Department of Energy
Albuquerque Operations Office
P.O. Box 5400
Albuquerque, New Mexico 87115

Please reference our letter dated October 9, 1987, DOE responses to NRC comments on the Slick Rock draft Remedial Action Plan. In our letter we had proposed to meet with the NRC and State of Colorado to discuss concerns of the possibility of community well (Well 2134F) becoming contaminated by the final stabilized pile or Dolores River alluvium. Since a meeting could not be coordinated, we have enclosed an evaluation for potential contamination of the well.

SLICK ROCK WATER SUPPLY EVALUATION

Figure 2. CROSS SECTION THROUGH WELLS 688, 634, and 507, SLICK ROCK, COLORADO SITE

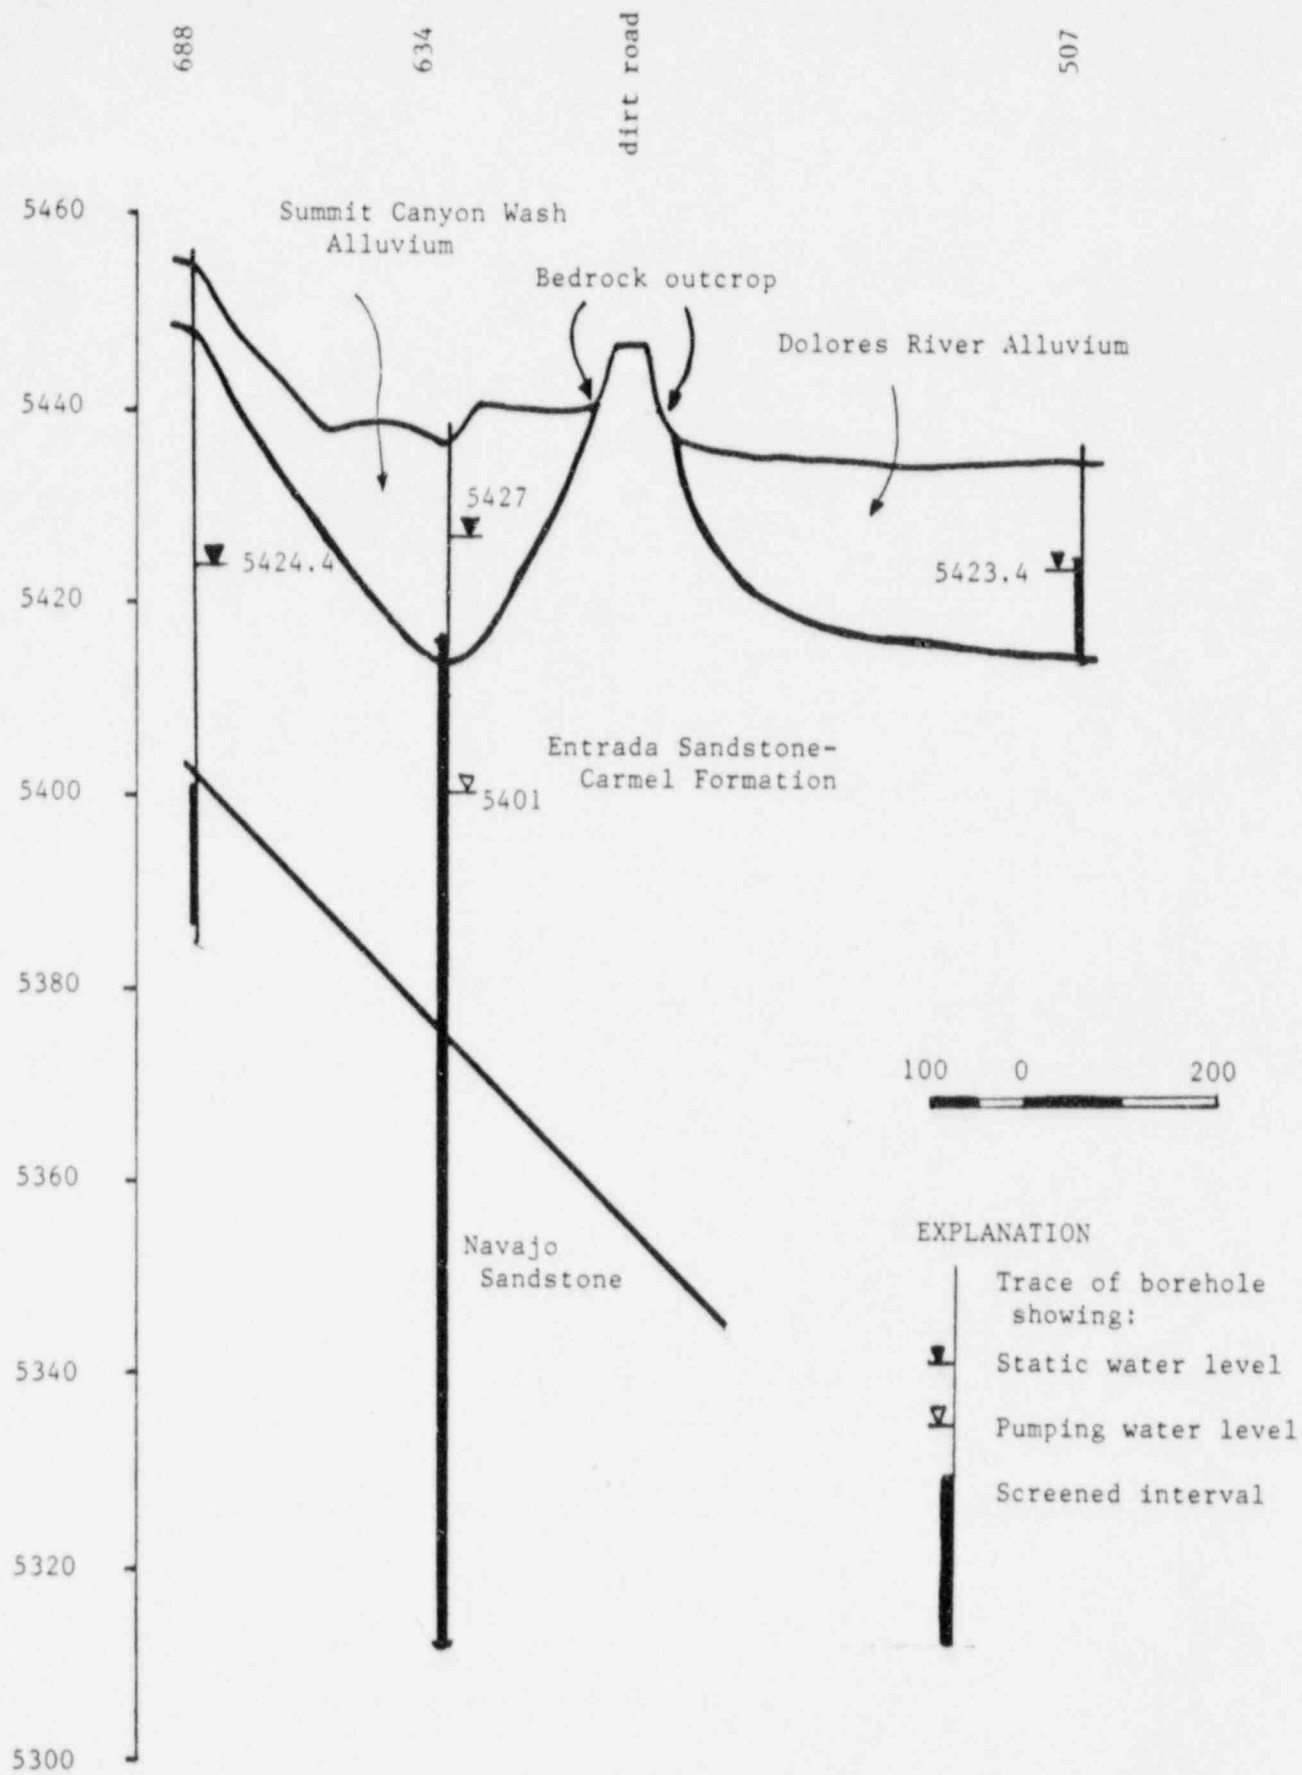
General features of the Slick Rock UMTRA site are shown on Figure 1. Lithologic details and static groundwater elevations for well 634 and nearby monitor wells are shown in Table 1, and a cross section constructed through these wells is shown as Figure 2. The static groundwater elevation measured in well 688, a nearby well completed in the Navajo Sandstone, is higher than that in well 507, a nearby well completed in the Dolores River alluvium. Thus, except for a localized area of potentiometric depression near well 634 when it is pumping, no hydraulic potential exists for flow from the contaminated alluvium into the Navajo Sandstone. As determined from slug withdrawal tests performed on well 688, the Navajo Sandstone is relatively transmissive and the potentiometric surface recovers rapidly. Transient potentiometric effects caused by the pumping of well 634 probably do not transmit across the Entrada Sandstone-Carmel Formation aquitard.

The Summit Canyon Wash alluvium will not become contaminated because it is stratigraphically separated from the Dolores River alluvium by the low-hydraulic conductivity Entrada Sandstone-Carmel Formation. Laboratory measurements on core samples yield a vertical saturated hydraulic conductivity of $6.4 \text{ E-}10 \text{ cm/sec}$ for the Entrada Sandstone-Carmel Formation. In the unlikely event that any hydraulic gradient develops into the Entrada Sandstone-Carmel Formation, flow would be restricted by this relatively low conductivity.
